# **C3 Results from Visual Inspection**

J. H. Chrzanowski  
March 7, 2006

# Lead Area

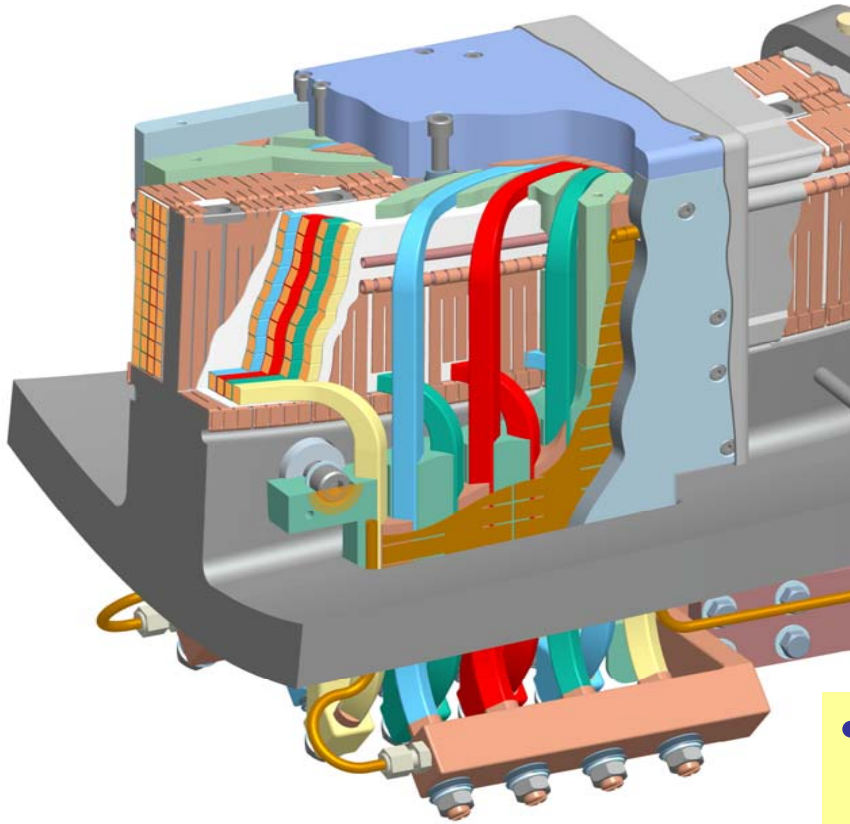
- Significant edge was left in lead slot
- Cannot use as is G-11 lead filler will not fit due to clearance
- **This item not identified on NCR**
- Grinding required

- G-11 Lead fillers fit tight to the lead opening clearance

# Miscellaneous Items

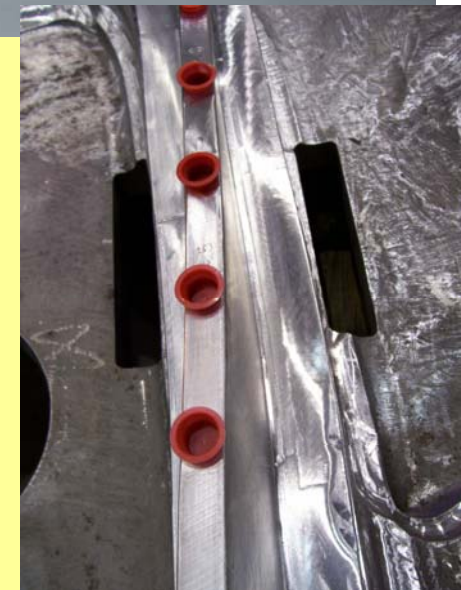
- Carbon steel bushings left in casting (4)
- Need to be drilled out

- 35 c'bored holes too deep
- New bushings need to be manufactured

# Permeability Concerns

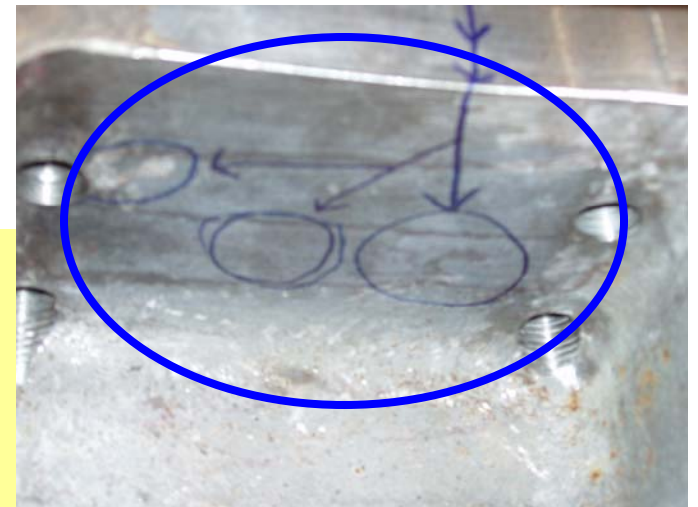
- A number of areas were identified with high Permeability [dark areas]
- Permeability  $>1.02 \mu$
- In-house grinding is required
- This was not an inspection requirement but foundry and Major tool needs to aware of contamination from ferrite lifting chains etc.

# Poloidal Break

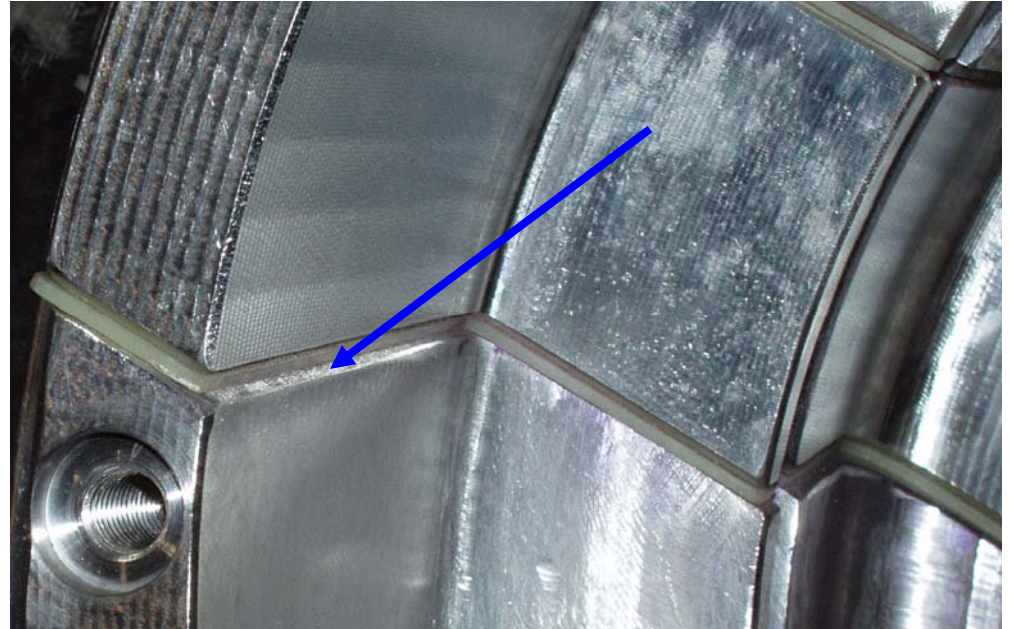
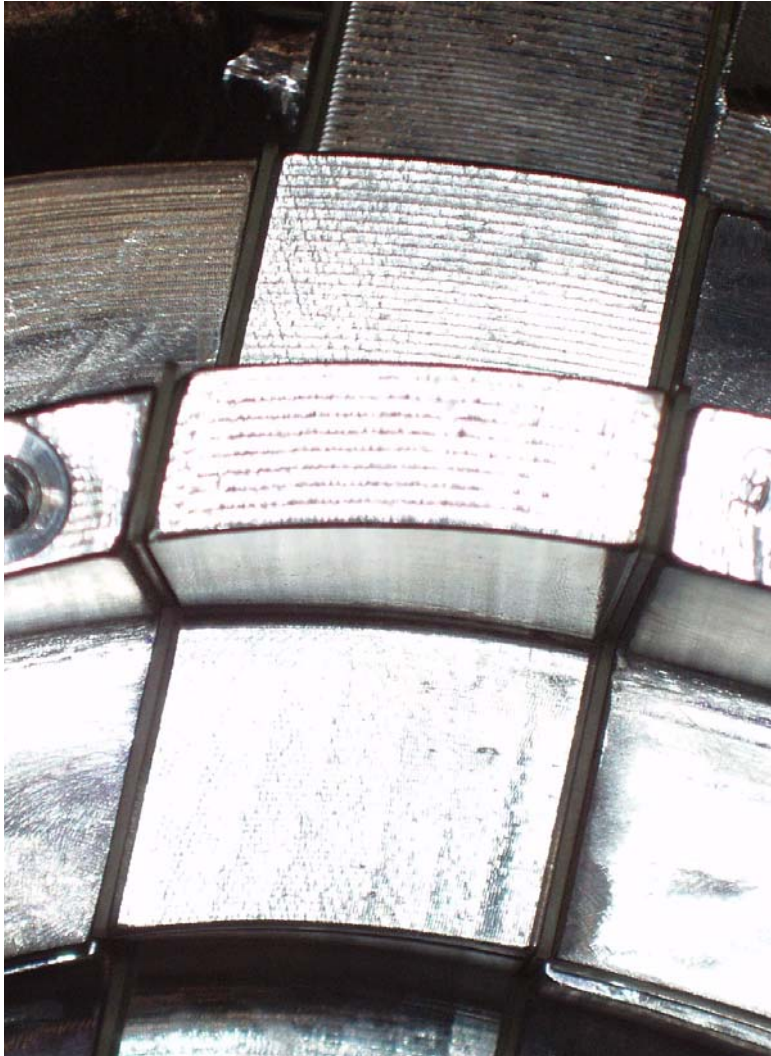
- Poloidal break insulator and shim is shifted
- Adjacent surfaces do not align
- Some rework will be required
- **Not identified on NCR**

# Poloidal Break- continued

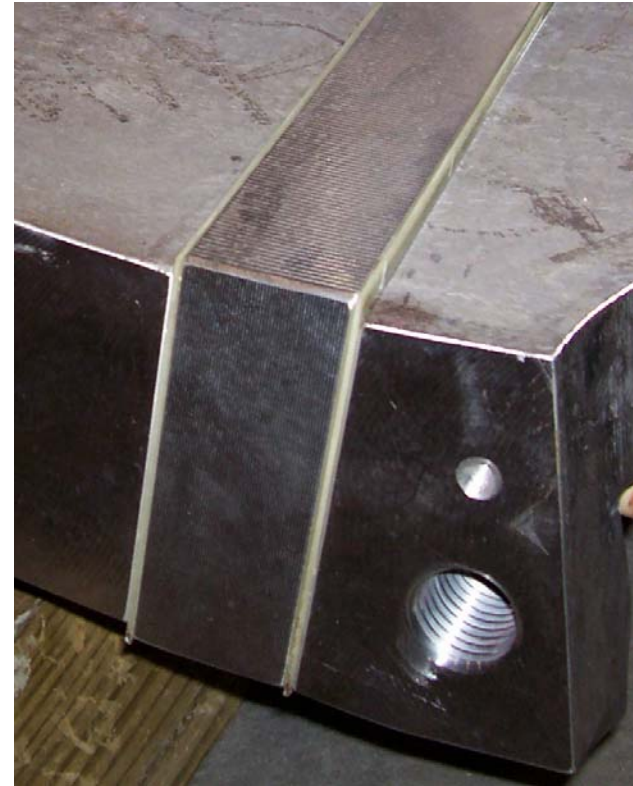
- G-11 insulator extends beyond flange [one side]
- Insulators need to be trimmed

# Misaligned Holes

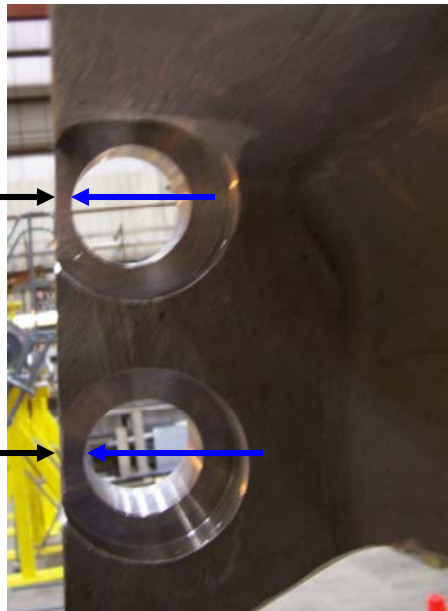
1/4 in. hole  
to edge

3/8 in. hole  
to edge

- Flange holes appear to be too close to edge
- Cause unknown?

# Excess material

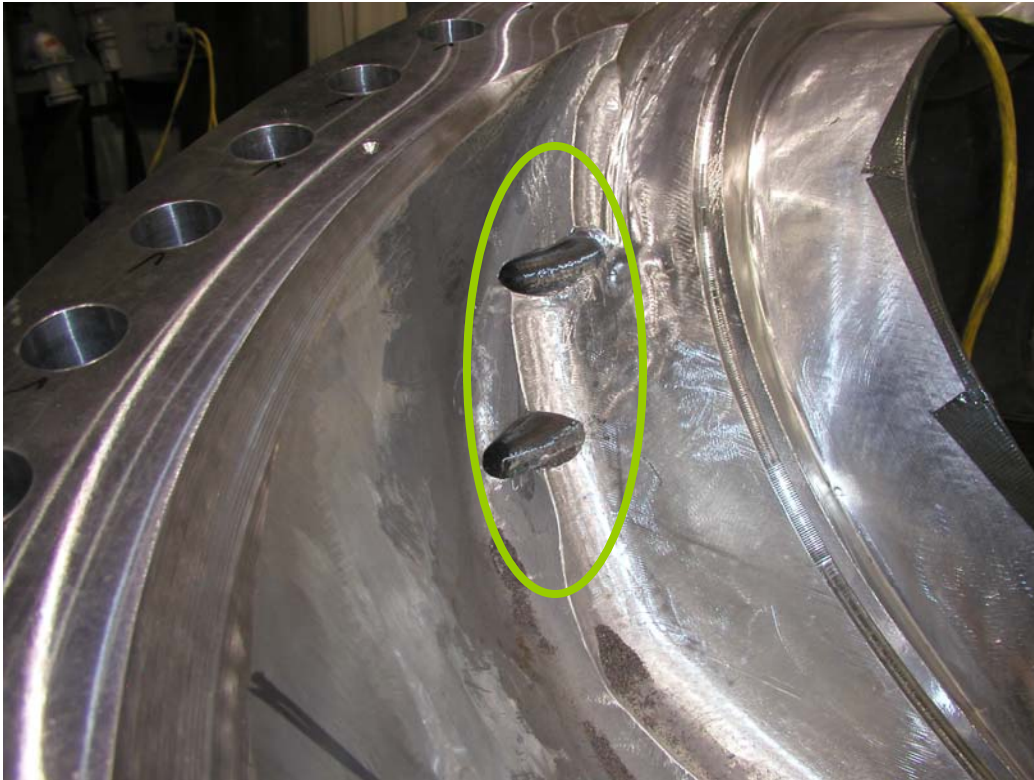
- Excess material remained overhanging holes preventing straight line of sight
- Excess material had to be ground to provide clearance
- Should have been found

# Flange Hole Clearances

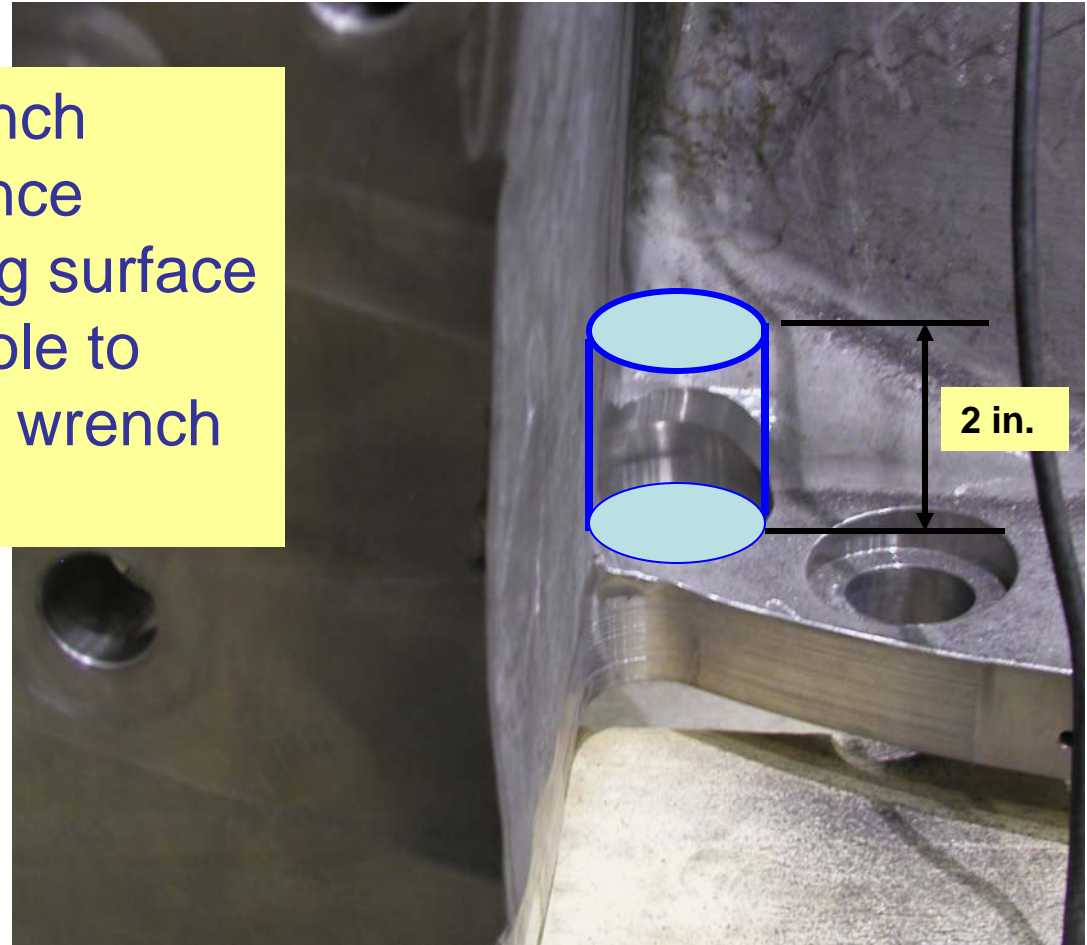
**It appears that there is over cast material on the C3 winding form in some of the flange bolt area, causing potential problems during assembly.**

- NCSX needs 2 inch minimum clearance above the casting surface at each flange hole to allow for nut and wrench clearances
